Access Compliance Report

Public Rights-of-Way

(Curb Ramps)

Intersection ID: N/A	Main Street: TAMARACK DR	Cross Street: SINGLELEAF LN	Location: E
ADA ID: 324B40A93A15	Ramp Type: Perp	Initial Pass/Fail: Fail	Overall Compliance: No
Severity Score: 13.75			
Codes/Mitigation Info/Possible Solution		Field Measurements/Component Compliance

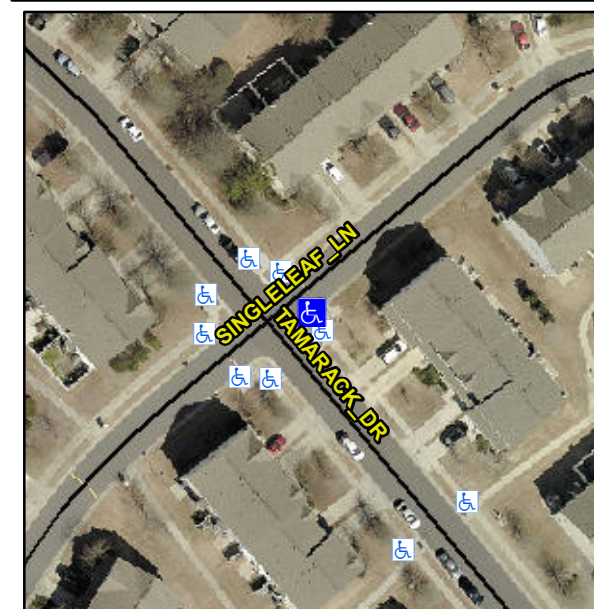
Not Found, R304.2.2, R304.5.3

Compliance	Description	Data	Compliance	Description	Data
N/A	Ramp Length (in)	48.0	No	Ramp Slope (%)	9.2
Yes	Ramp Width (in)	48.0	No	Ramp XSlope (%)	2.2
N/A	Flare Type LT	N/A	N/A	Flare Type RT	N/A
N/A	Flare Slope LT (%)	N/A	N/A	Flare Slope RT (%)	N/A
N/A	Flare Traversable LT?	No	N/A	Flare Traversable RT?	No
N/A	Landing Length (in)	N/A	N/A	DWS Provided?	N/A
N/A	Landing Width (in)	N/A	N/A	DWS Contrast?	N/A
N/A	Landing Slope (%)	N/A	N/A	DWS Length (in)	N/A
N/A	Landing X Slope (%)	N/A	N/A	DWS Full Width?	N/A
N/A	Landing Curb? (Y/N)	N/A	N/A	DWS Offset (in)	N/A
N/A	Shared Landing?	N/A			
N/A	Gutter Ponding?	N/A	N/A	Gutter Slope (%)	N/A
N/A	Gutter Lip Ht (in)	N/A	N/A	Gutter X Slope (%)	N/A
N/A	Painted X Walk1?	No	N/A	Painted X Walk2?	N/A
	X Walk 1 Direction	To NW		X Walk 2 Direction	N/A
N/A	X Walk 1 Width (in)	N/A	N/A	X Walk 2 Width (in)	N/A
	X Walk 1 Slope (%)	0.1		X Walk 2 Slope (%)	N/A
	X Walk 1 X Slope (%)	1.3		X Walk 2 X Slope (%)	N/A

Remove & Replace Entire Ramp.
